Re: Technical Deficiency Notification Responses
Water Obstruction & Encroachment Permit
DEP Application No. E3683225-006 | APS ID 1139499 | AUTH ID 1530838
Northeast Supply Enhancement Project - Quarryville Loop
Drumore, East Drumore, and Eden Townships, Lancaster County

ATTACHMENT 1
TECHNICAL RESPONSE

Technical Deficiency Notification Responses
Water Obstruction & Encroachment Permit
DEP Application No. E3683225-006 | APS ID 1139499 | AUTH ID 1530838
Northeast Supply Enhancement Project - Quarryville Loop
Drumore, East Drumore, and Eden Townships, Lancaster County

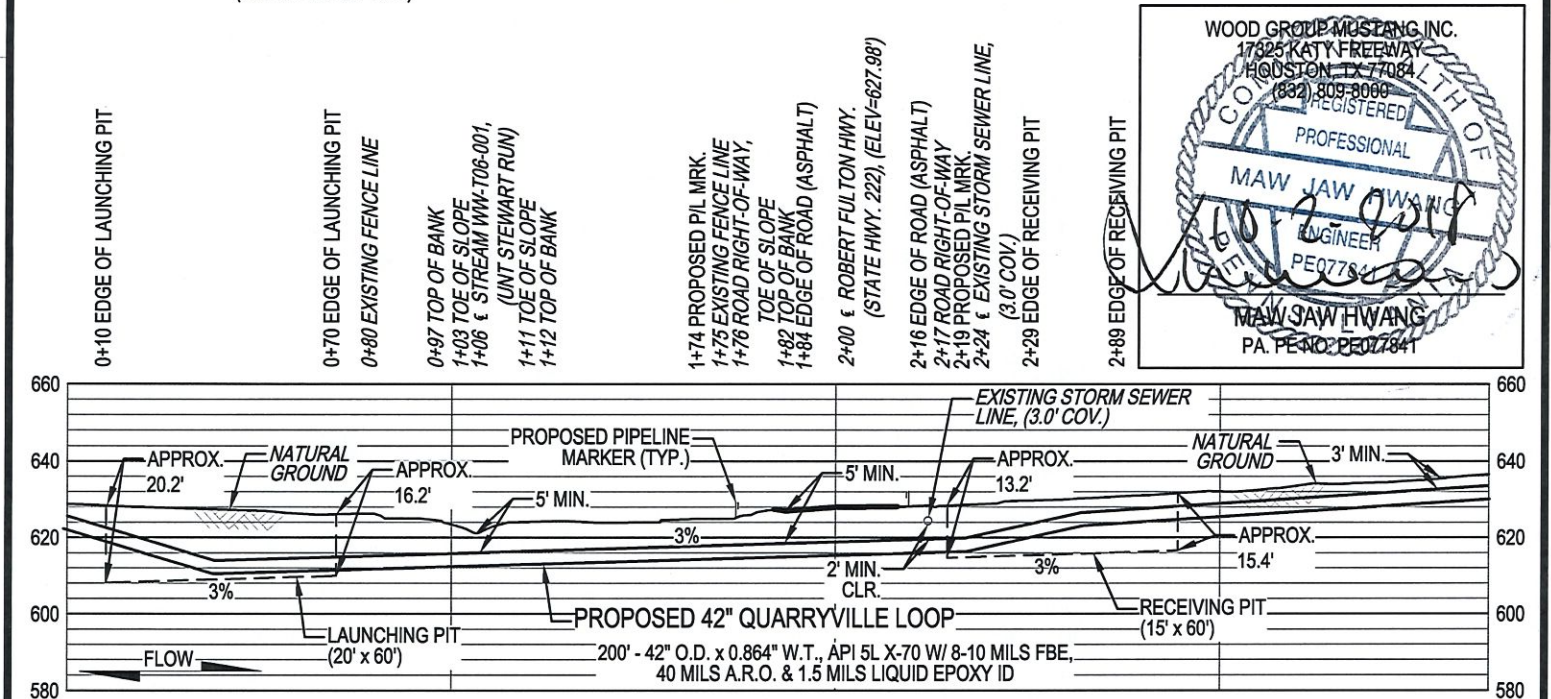
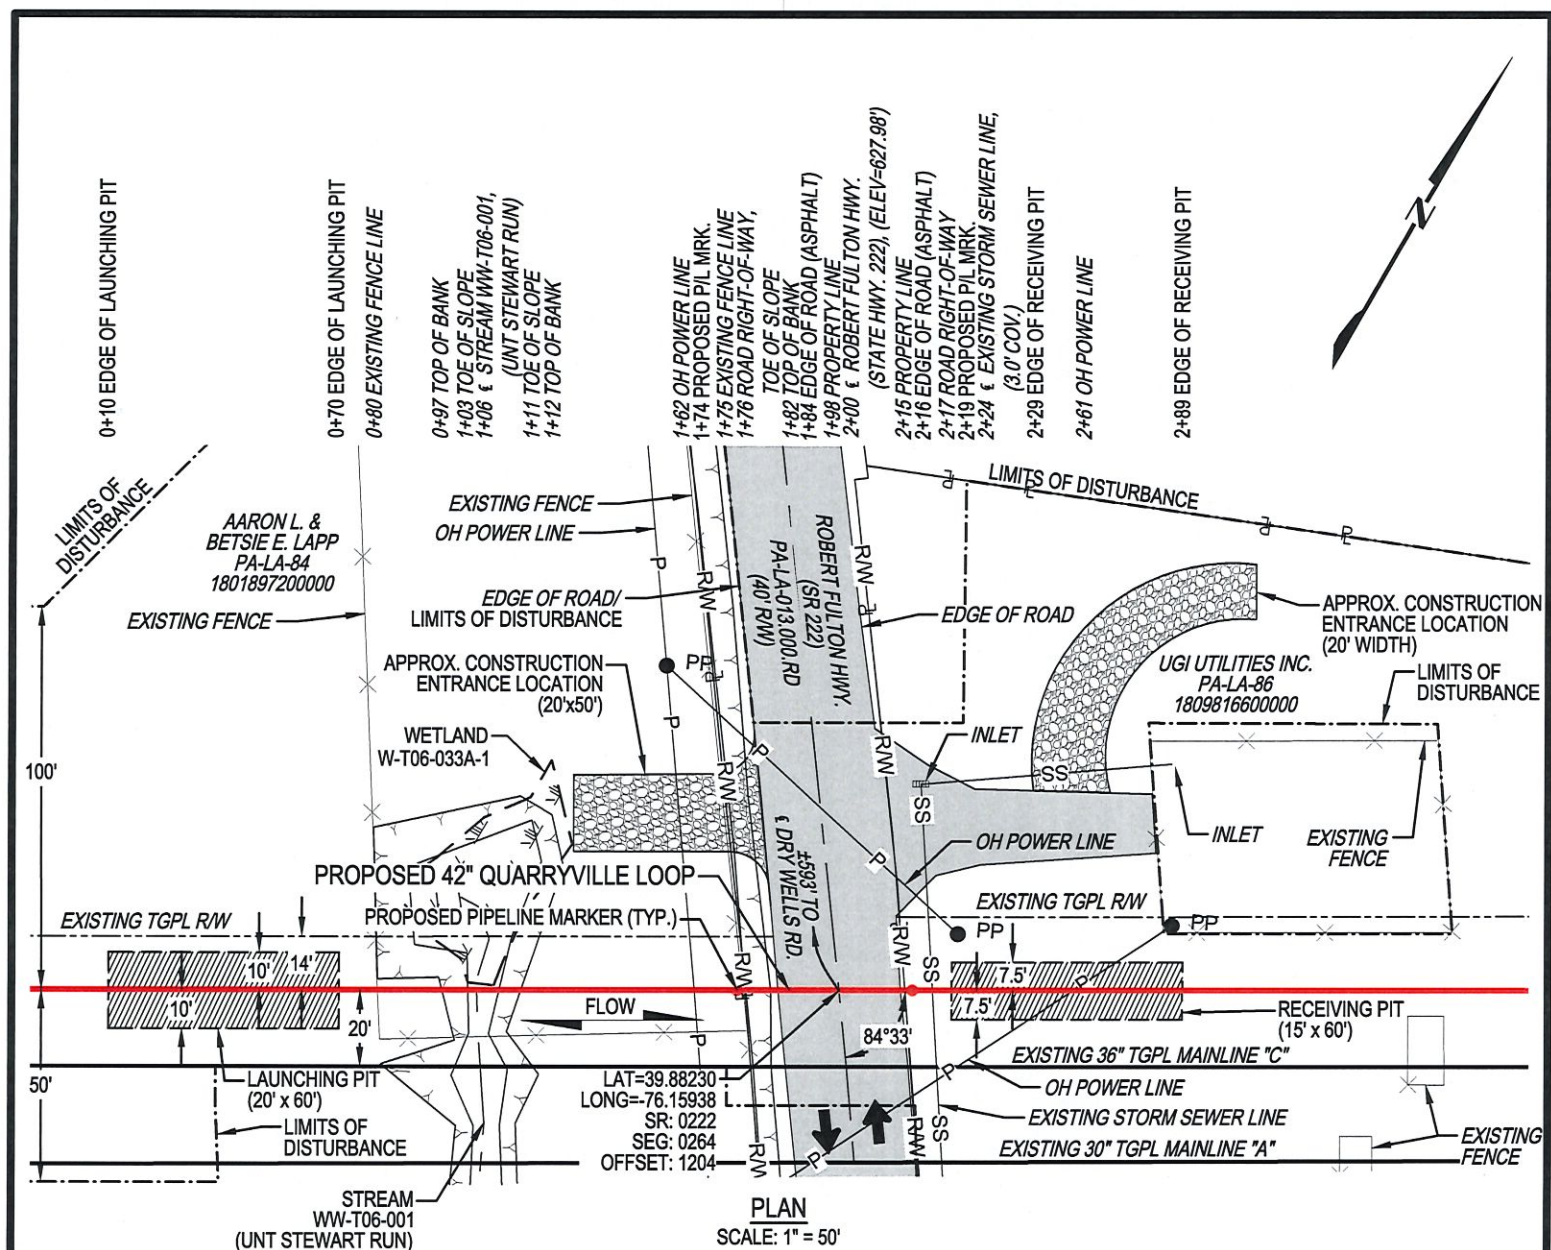
Comment #13. Please clarify the proposed construction method for Crossing 11, which includes an unnamed tributary to Stewart Run (WW-T06-001) and wetland W-T06-003A-1. The ARIT states this crossing will be completed using a conventional bore and timber mats, while the Alternatives Analysis narrative and Table 3-1 and 3-2 within Exhibit 22 indicate open cut construction. These documents conflict. Please confirm the correct construction method and revise the application for consistency. If conventional bore is proposed, include a discussion of how bore pit depth concerns will be addressed. [25 Pa Code § 105.21(a)(1)]

Response: The ARIT is correct. Crossing 11 will be completed using a conventional bore and timber mats. The Alternatives Analysis and Table 3-1 and 3-2 within Exhibit 22 have been revised.

The bore pit depth is designed to bore under the Resource Crossing and Robert Fulton Highway to provide sufficient coverage required for the road crossing. A copy of the road crossing permit that depicts the plan and profile of the bore crossing is provided (Attachment 2).

The conventional bore was designed with the following considerations:

- There is no space to install the bore pit between the stream and the highway.
- There is an overhead power line west of the road that doesn't allow installation of the bore pit in that location.
- Boring both the stream and the highway in one bore provides the least amount of ground disturbance.
- The bore pit achieves the five-foot depth requirement by Penn DOT.
- Bore pits 20 ft and deeper will require an engineered excavation solution signed by a Professional Engineer mostly made up of reinforced trench box systems.

Bore pit dewatering activities will discharge into an upland location and will not impact the stream channel.
